2020 Thermo Fisher Fill Site

MEMO

Application: ECSWM Permit
Property Location: Outlot 4 CSM 15033
Review Date: April 7, 2020
Planning Staff Review #1

**Thermo Electron Scientific ECSWM Permit
OL 4 of CSM 15033
Public Works Review #1**

SHEET NO.
GR-01

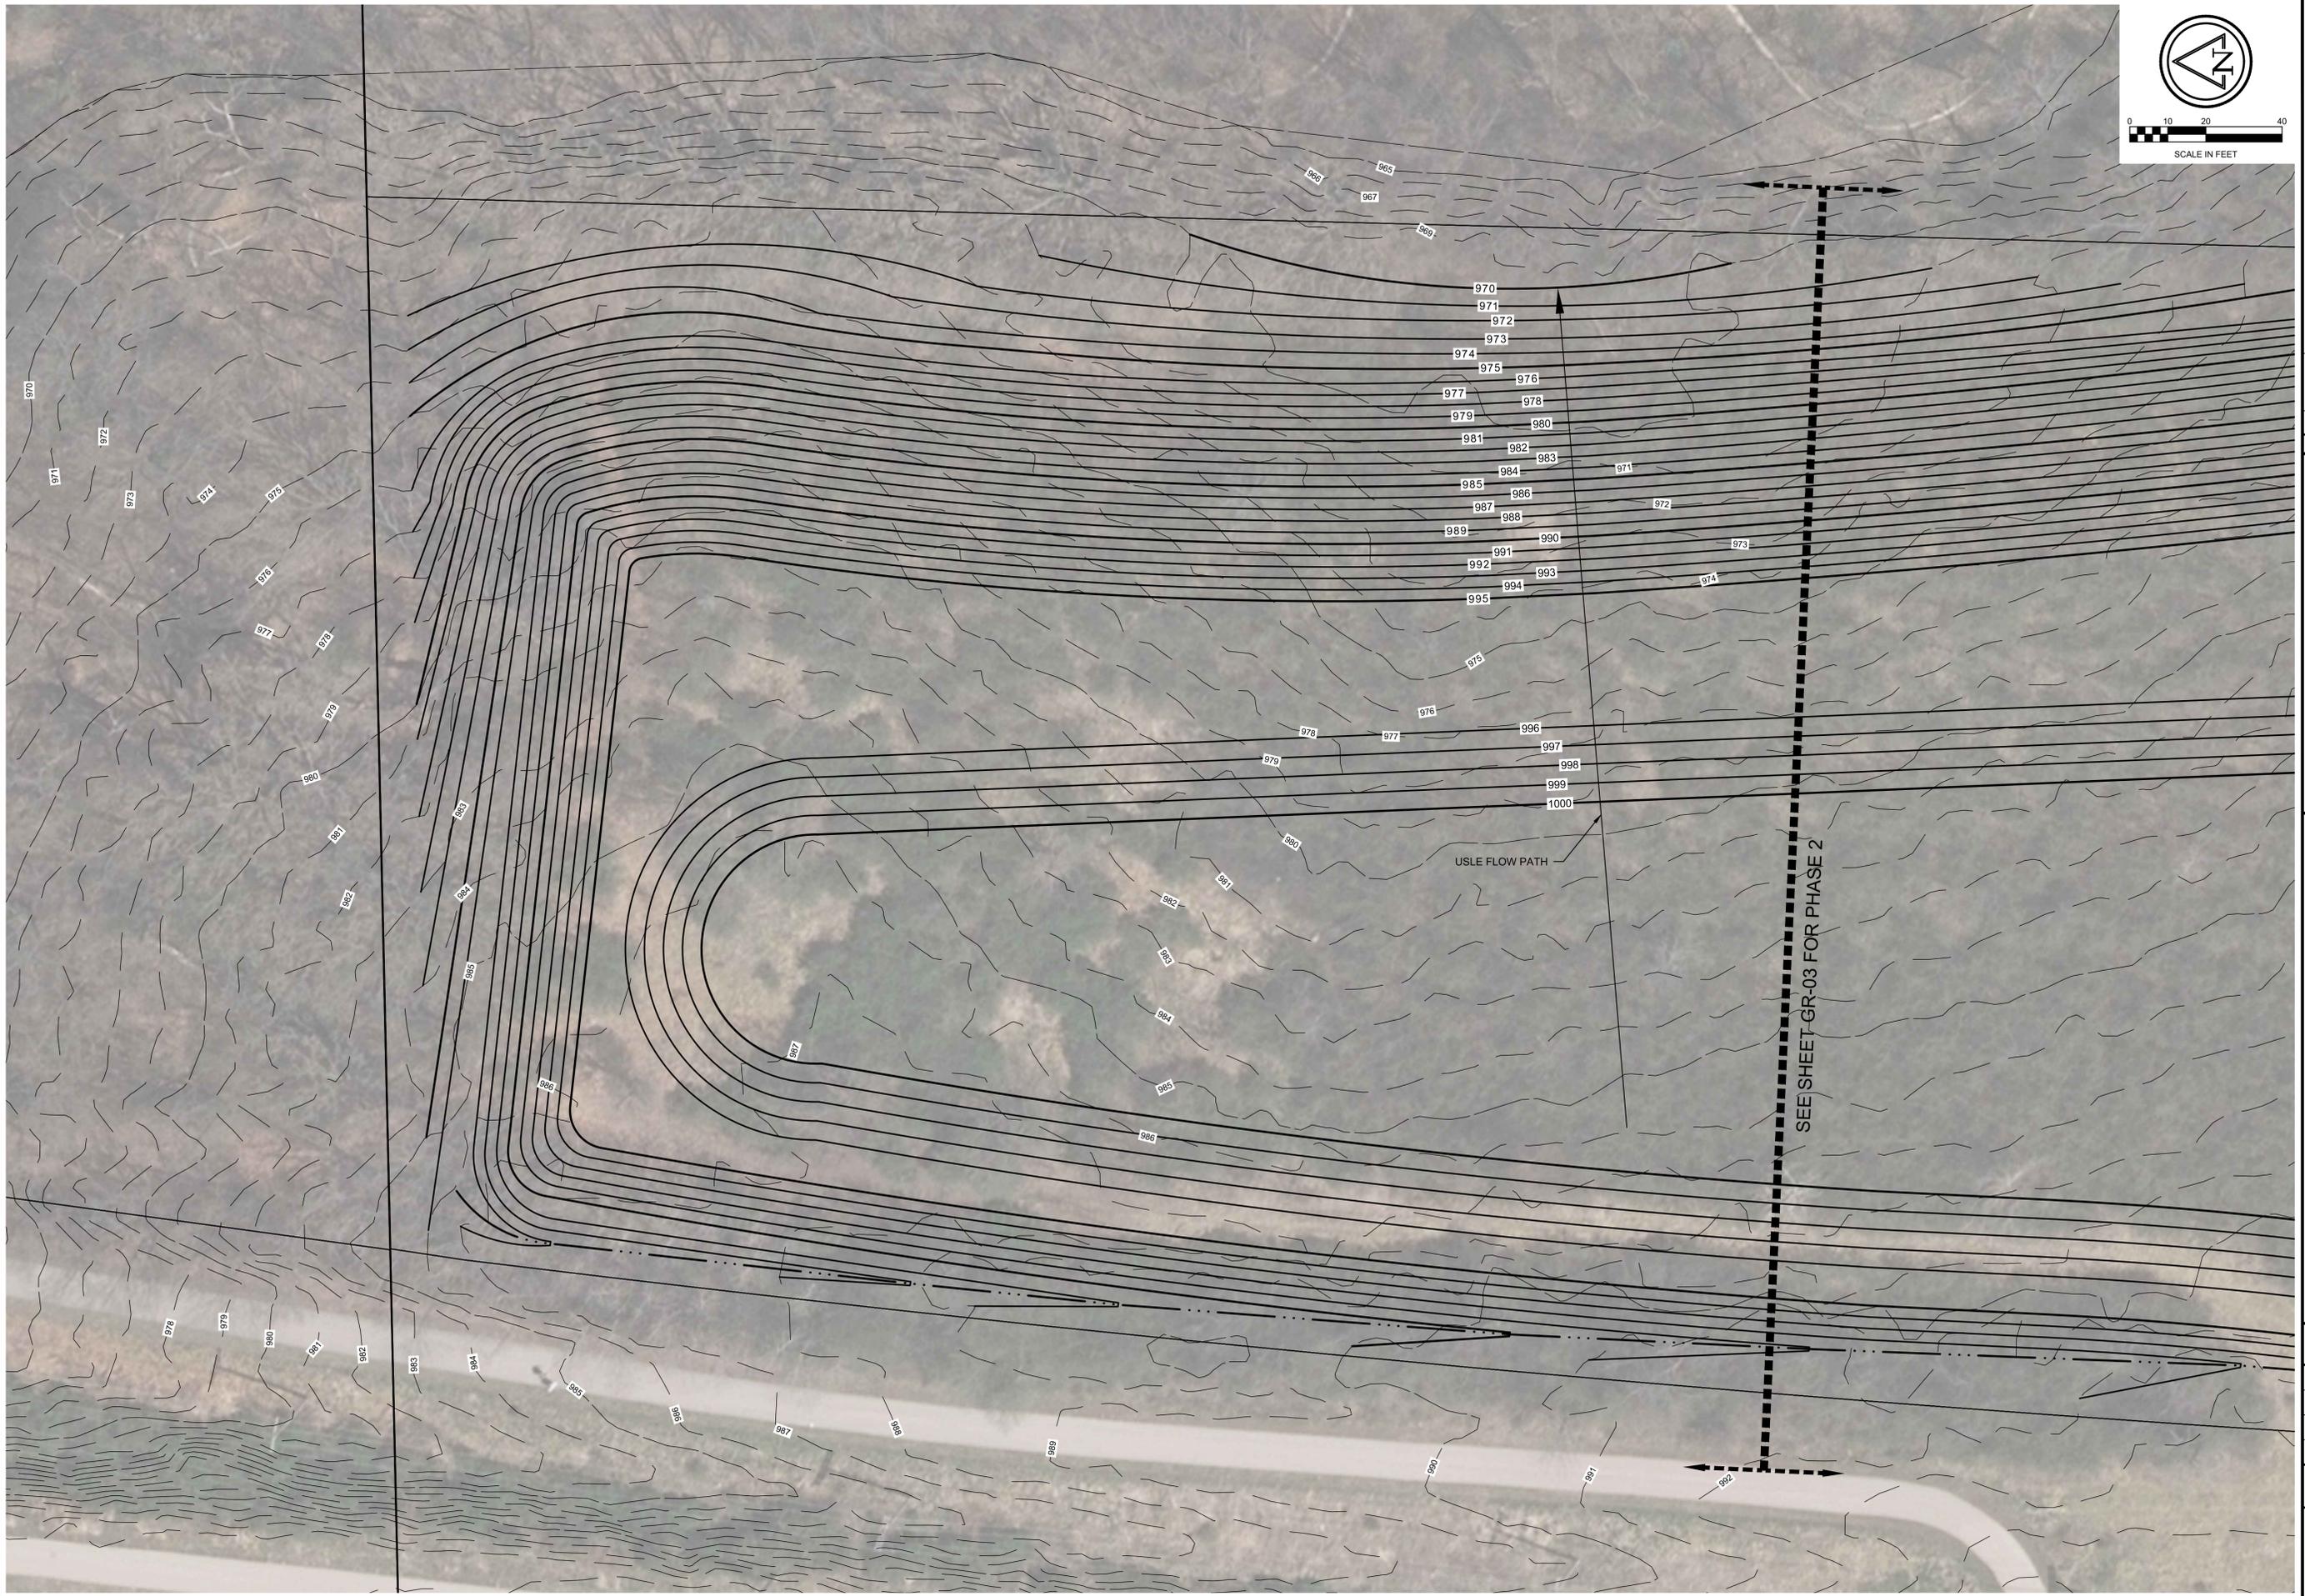
5. Label proposed slopes. (TB)

Response: Proposed slopes labeled on sheet GR-01.
